FERMI 2

AMENDMENT TO FACILITY OPERATING LICENSE

Amendment No. 128
License No. NPF-43

ATTACHMENT TO LICENSE AMENDMENT NO. 128

FIGURE 3.4.10-1

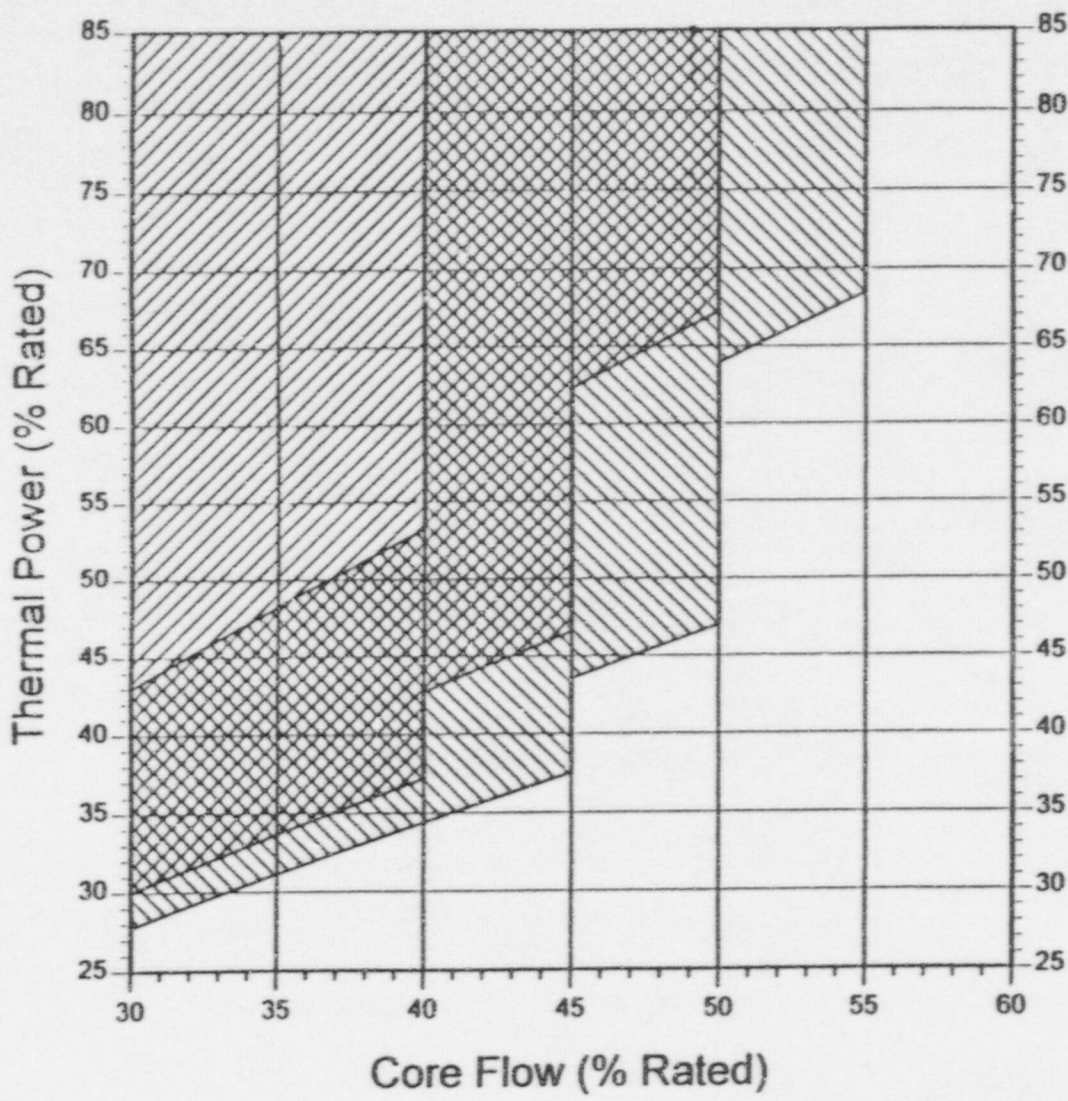
- 3.4.10 The Reactor core shall not exhibit core thermal hydraulic instability or be operated in the Scram or Exit Regions as specified in Figure 3.4.10-1.

- a. With the Reactor operating in the Scram Region as specified in Figure 3.4.10-1, immediately place the Reactor Mode Switch in the Shutdown position.
- b. With the Reactor operating in the Exit Region as specified in Figure 3.4.10-1, immediately initiate action to leave the Exit Region by inserting control rods or by increasing core flow.*
- c. If core thermal hydraulic instability occurs as evidenced by a sustained increase in APRM or LPRM peak-to-peak noise level reaching 2 or more times its initial level, and occurring with a characteristic period of less than 3 seconds, immediately place the Reactor Mode Switch in the Shutdown position.

- 4.4.10.1 The provisions of Specification 4.0.4 are not applicable.
- 4.4.10.2 When operating within the Stability Awareness Region as specified in Figure 3.4.10-1, verify that the reactor core is not exhibiting core thermal hydraulic instability by monitoring APRM and LPRM signals immediately and at least once every hour.

- 
Scram Region:
 >96% Rod Line, <40% Core Flow
- 
Exit Region:
 Not in Scram Region
 - and -
 >67% Rod Line, <40% Core Flow
 >77% Rod Line, <45% Core Flow
 >103% Rod Line, <50% Core Flow
- 
Stability Awareness Region:
 Not in Scram or Exit Regions
 - and -
 >62% Rod Line, <45% Core Flow
 >72% Rod Line, <50% Core Flow
 >98% Rod Line, <55% Core Flow
